Subject: Service Action S39920 – XC40 Tailgate Handle Modification

**Service Action S39920: XC40 Tailgate Handle Modification  
Model Year 2019 - 2020 XC40**

QB Instruction VCC-514275-1

| <b>Title</b>  | Outer tailgate/trunk lid handle | <b>Page</b>              | 1 ( 5 ) |

### Removal

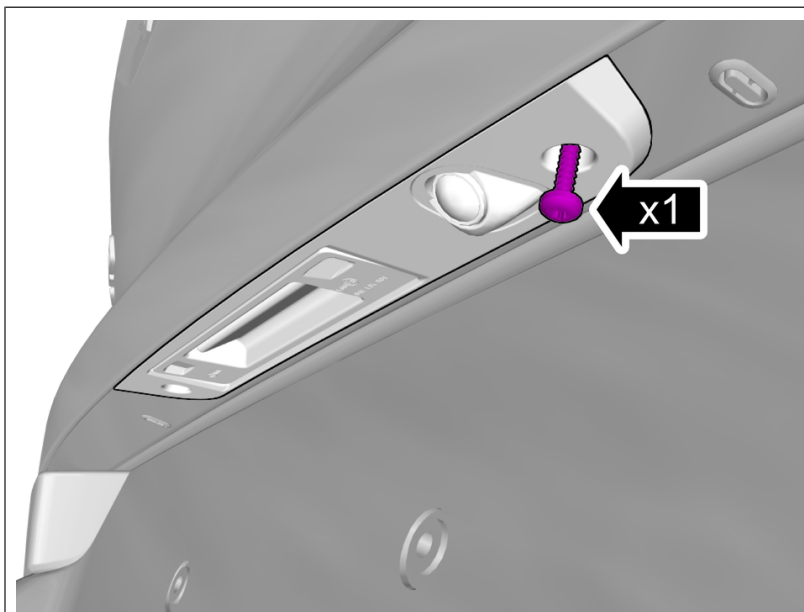
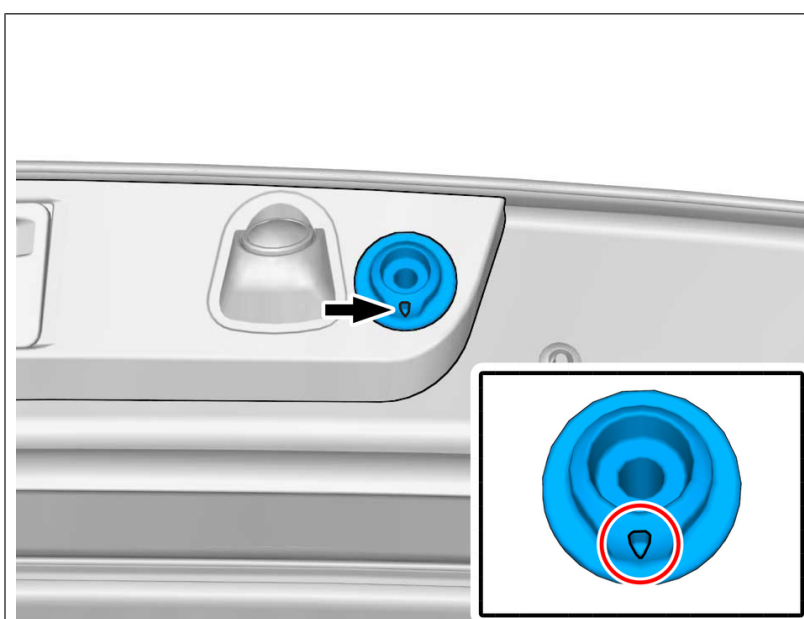
**Note! One side at a time.**

Remove the screw.  
The part is not to be reused.

### Installation

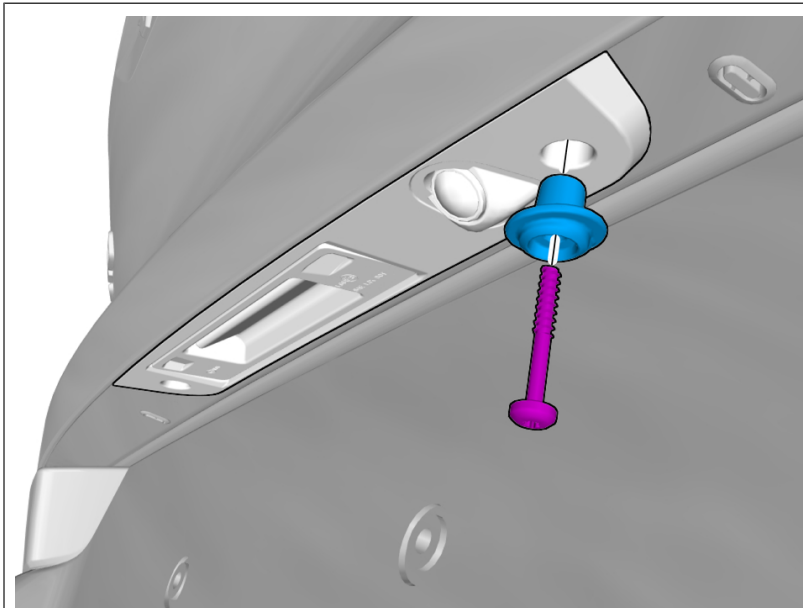
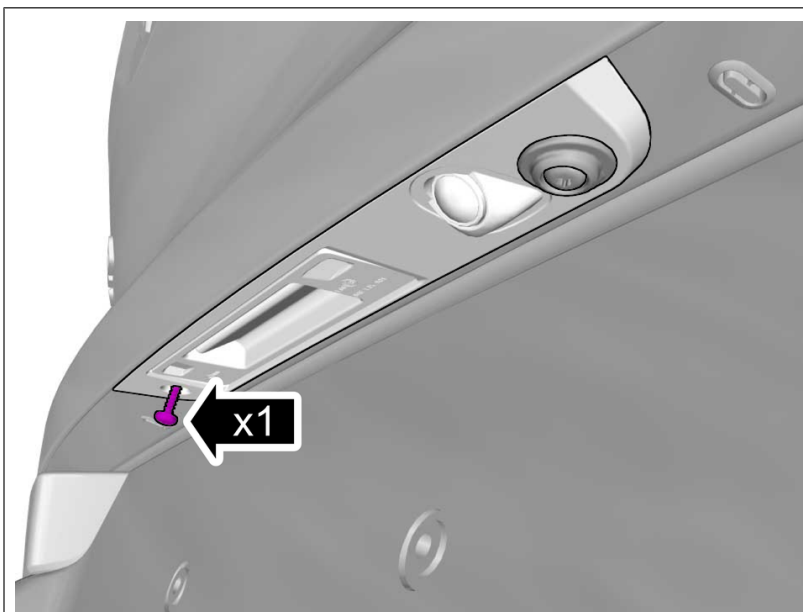
Note the position.

Install component/components from the repair kit.

Tighten the screw.

Tailgate/trunklid handle , 2 Nm

**Removal**

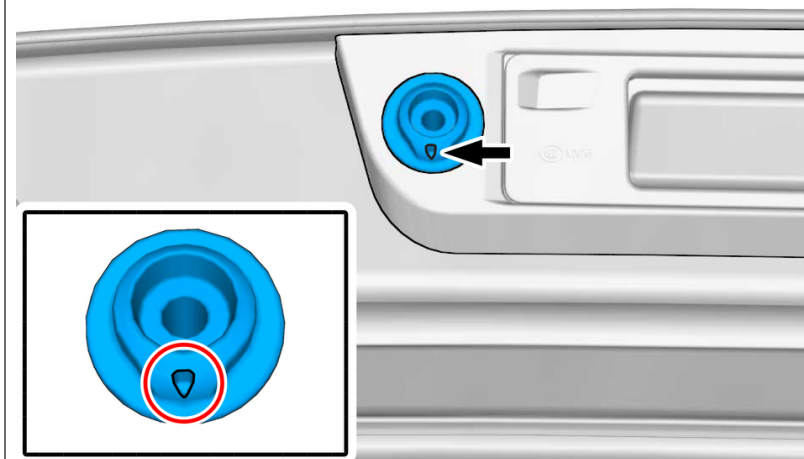
**Note! One side at a time.**

Remove the screw.

The part is not to be reused.

## Installation

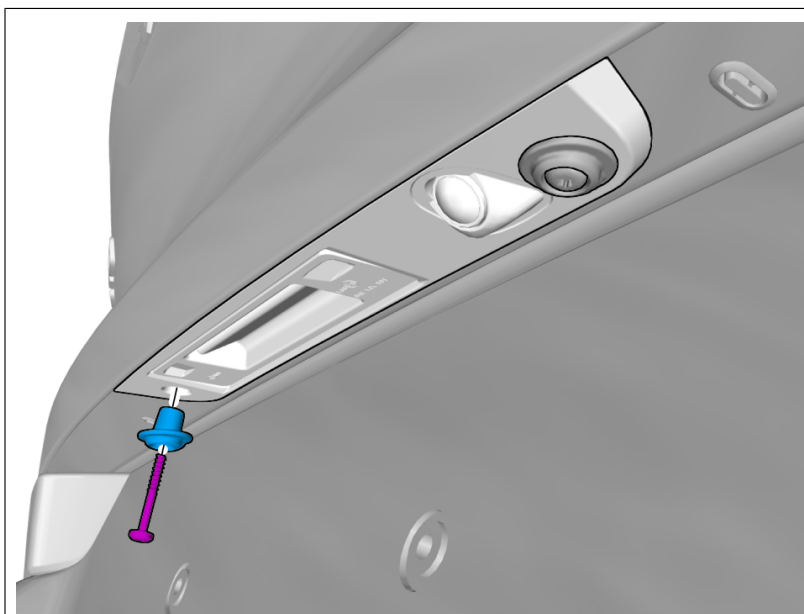
Note the position.

Install component/components from the repair kit.

Tighten the screw.

Tailgate/trunklid handle , 2 Nm
